Subject: MIL is ON, DTCs P1411, P1423 are Stored in DTC

Model(s): Touareg

Number: **05–09**

Date: Oct. 26, 2005

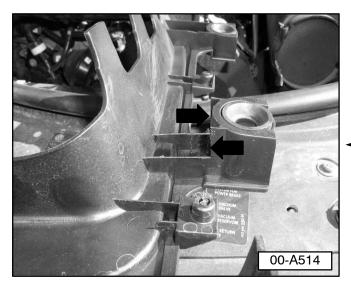
Secondary Air Injection Valve, Solenoid Valve -N112- is damaged when left rear corner of engine cover are installed after service has been performed to engine:

◆ Modify engine cover as follows:

Do not use cutting pliers, damage will occur to cover. A File or Die Grinder is recommended.

### DO NOT remove entire ear of engine cover.

- Remove engine cover and invert.
- Remove support material between cover and ear of cover:
  - File or grind to a depth of 5 mm behind the cover ear (arrows) and remove material as shown.
  - Check engine cover fit, allow approximately 26 mm (1 in.) at point of contact with Air Injection Solenoid Valve -N112-.
